MFN 05-153
Supplement 1

**Subject: Response to NRC Request for Additional Information Letter No. 1
Related to ESBWR Design Certification Application – Radiation
Protection – RAI 11.5.3-3 – Supplement 1**

RAI 11.5.3-3 – Supplement 1

**Evaluation of GE Responses to NRC RAI Letter No. 7
ESBWR DCD Rev. 1, Tier 2**

Figure 11.5-1. Location of Radiation Monitors

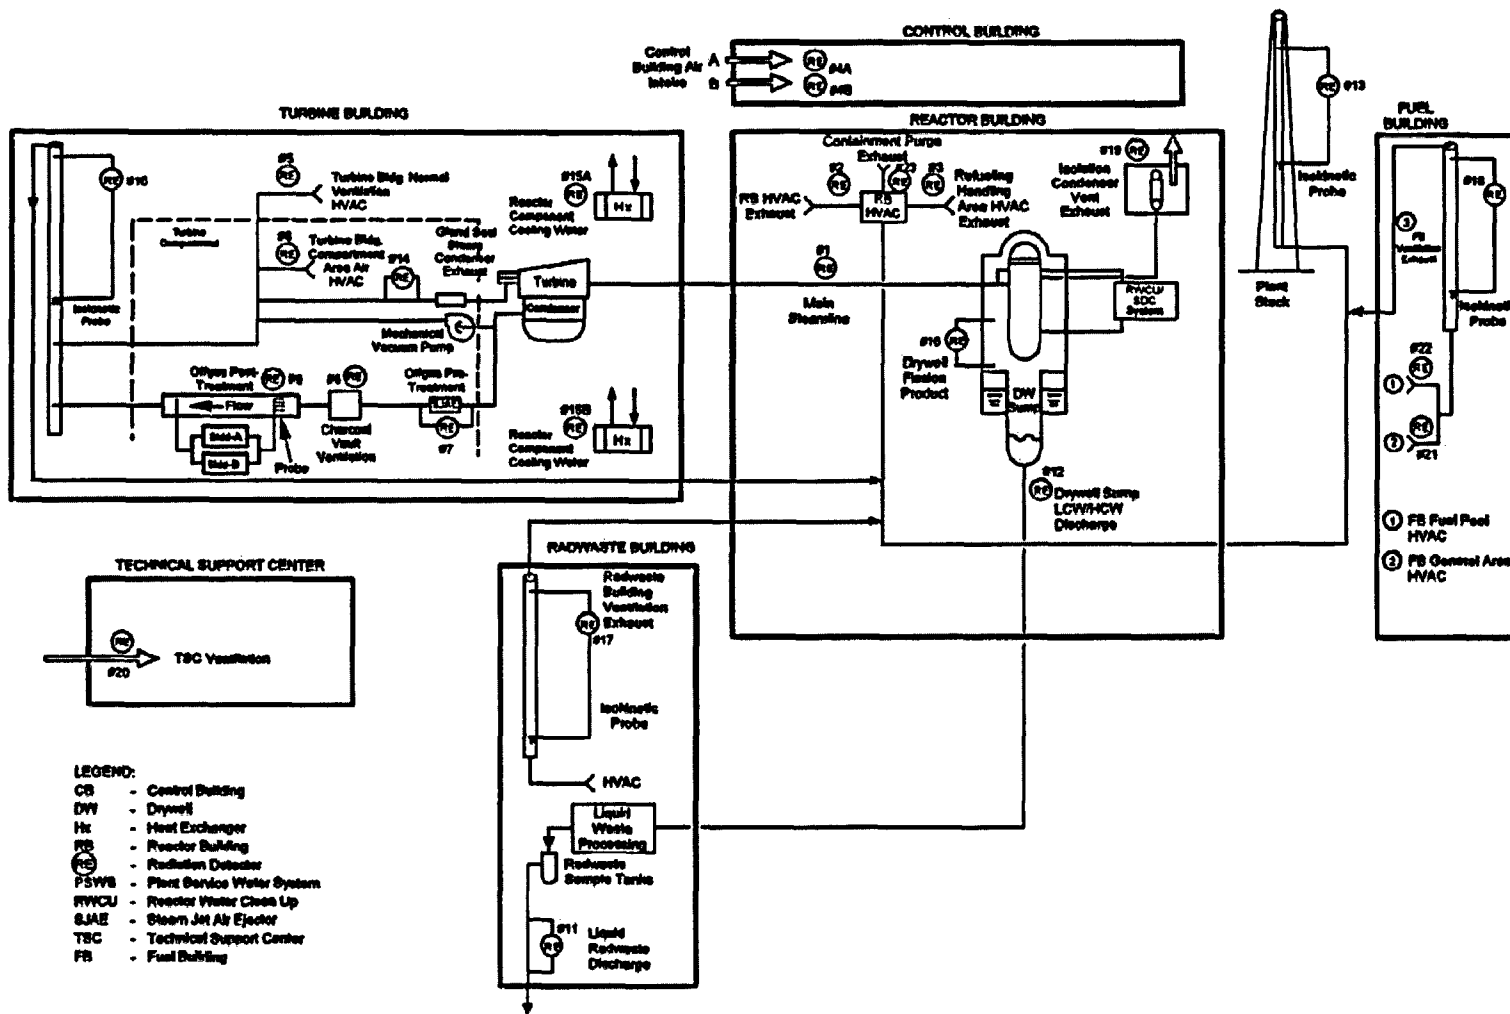
The designation of radiation monitoring systems and their respective ID codes are inconsistently presented in Table 11.5.3 and Figure 11.5-1. This section refers to Table 11.5-3 and Fig. 11.5-1 for information about the designation and ID codes of radiation monitoring systems. A review of instrumentation ID codes indicates that the numbering system is inconsistent for ID No. 21, 22 and 23. The system identified as No. 21 on Fig. 11.5-1 is not listed in Table 11.5-3 and its designation ("#21, COPS") and function are not described in the Section. As a result, ID codes No. 21 and 22 presented in Table 11.5-3 are not consistent with those shown in Fig. 11.5-1. Also, instrument ID code No. 23 is missing in Table 11.5-3, but is included in Fig. 11.5-1. Provide figures and tables (and text as needed) with updated information.

- a. Provide an explanation (footnote) as to how and where do discharges from the Isolation Condenser Vent Exhaust system tie into the Reactor Building HVAC system.
- b. Update drawing to show that the Offgas Post-Treatment RMS is equipped with an isokinetic probe - such as shown for the Turbine Building, Fuel Building, Radwaste Building, and Plant Stack.

DCD Chapter 11, Revision 1 corrected Figure 11.5-1 so that COPS is not shown and the numbers are adjusted, so that reference to COPS is eliminated.

The Isolation Condenser / Passive Containment Cooling (IC/PCC) pool is vented to the atmosphere as shown in ESBWR DCD Figure 5.1-3. It is not routed to Reactor Building HVAC. Under normal IC operating conditions, boil-off steam formed in the compartments containing Isolation Condenser heat exchangers are non-radioactive and has a slight positive pressure relative to station ambient. It is exhausted to atmosphere through large-diameter discharge vents after first passing through a large face area passive-type steam dryer. Moisture removed by the dryer from this boil-off steam is ducted back to the IC/PCC pool.

DCD Figure 11.5-1 will be revised to show the isokinetic probe for the Offgas Post-Treatment subsystem as noted in the attached markup.
